1:
Please can you provide proposed floor plans to show the alterations to rooms to allow the proposal (eg the change from bathroom to plant room, changes to bathroom on first floor etc)

3: Please can you provide flue technical details required to show the type proposed and its noise output.

Figure 9
Roof terminal VTK06 90-200

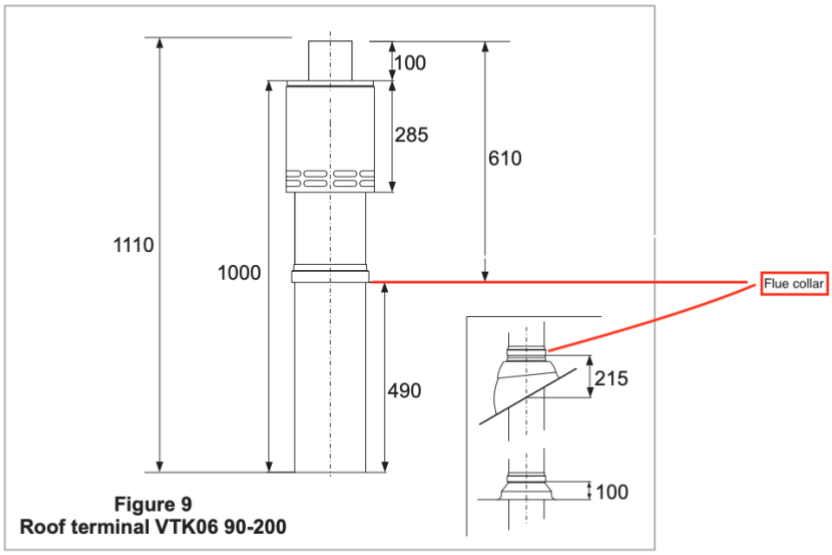
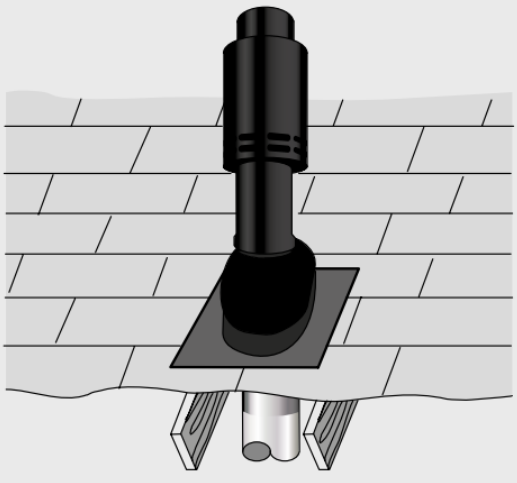
6:
Please can you provide a photo elevation to show the proposed flue, as well as metric measurements annotated on of its size and height

Please see below images of the flue.

Operating sound levels inside are 51.1db the manufacturer does not give a sound level for the external flue but it would be fair to assume it is approximately the same.

The flue collar has been marked in red. From the pitch of the roof to the top of the terminal will be 815mm, this includes the flashing kit.

Note: Range of pitch 22°-45°.
